From:
To: [Planning](#)
Subject: Re: NYM/2021/0230/NM
Date: 21 May 2021 10:58:28

PROJECT
The Bank House
Front Street
Grosmont
YO22 5PA

DRAWING
Floorplans, Section and Elevations as Proposed

DRAWN BY MT	CHECKED BY PT	SCALE @ A1 As indicated
PROJECT NO. 1786	DRAWING NO. P101	REVISION A

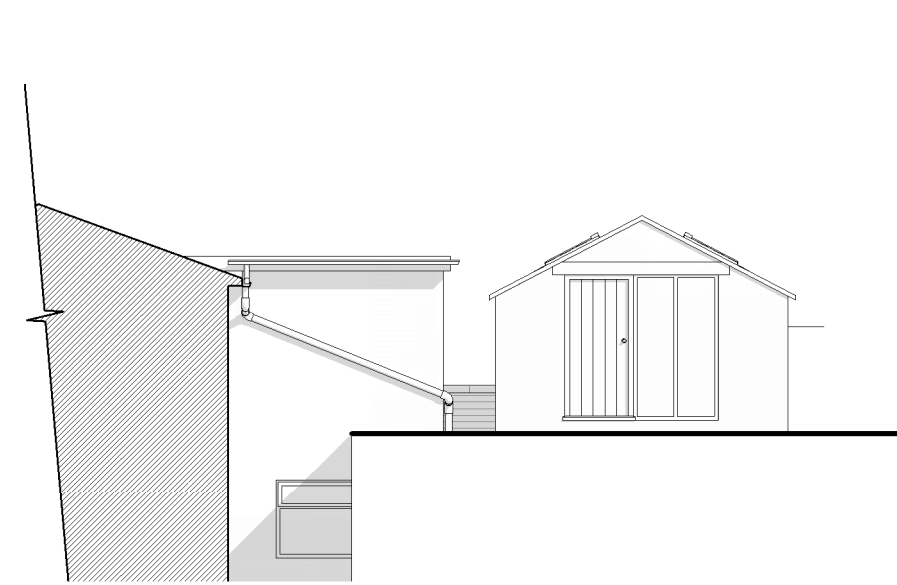
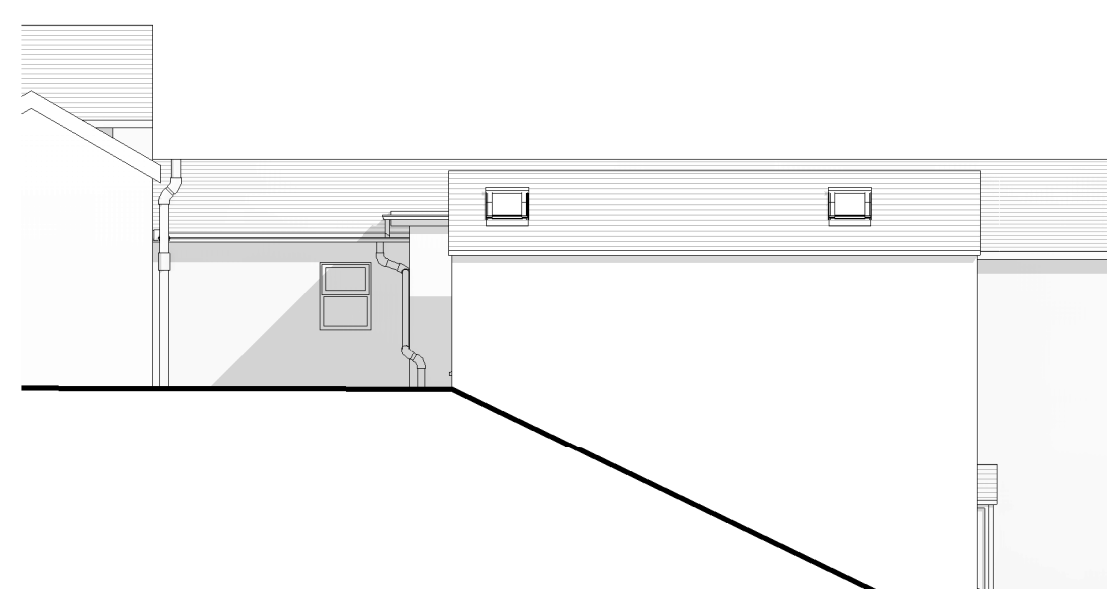
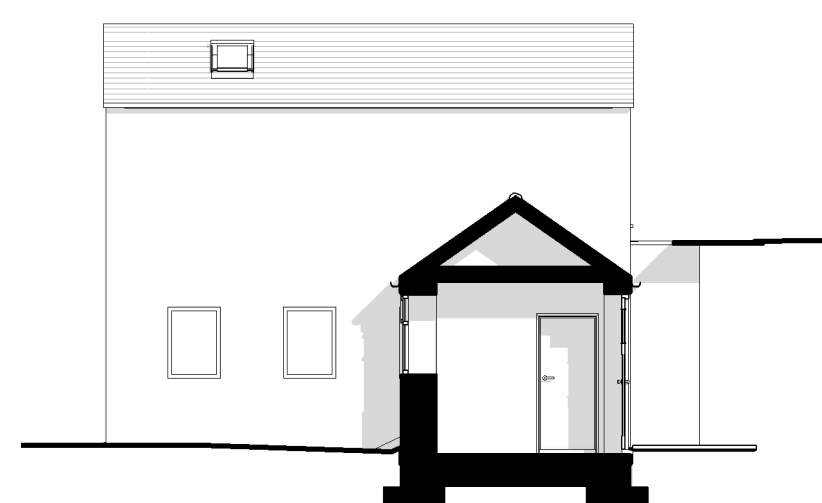
Thank you for the conversation on Friday 14th last indicating that a revised plan showing the reduced roof ridge height and change in roof pitch to accommodate the small increase in eaves height would be acceptable for the building at the rear of Bank House, Grosmont.

Attached is the revised plan from our architect to show the change. It would now be possible to have adequate ceiling heights necessitated by the small increase in floor height from the foundations.

Thus the proposed structure would now be no higher than original, the roof pitch would be a slightly less angle and the ridge height would not be higher.

- A Pitch revised to ensure that the proposed ridge height matches the existing ridge height 20/05/21
- # Revised drawing for proposed increased in roof height of 400mm 28/04/21
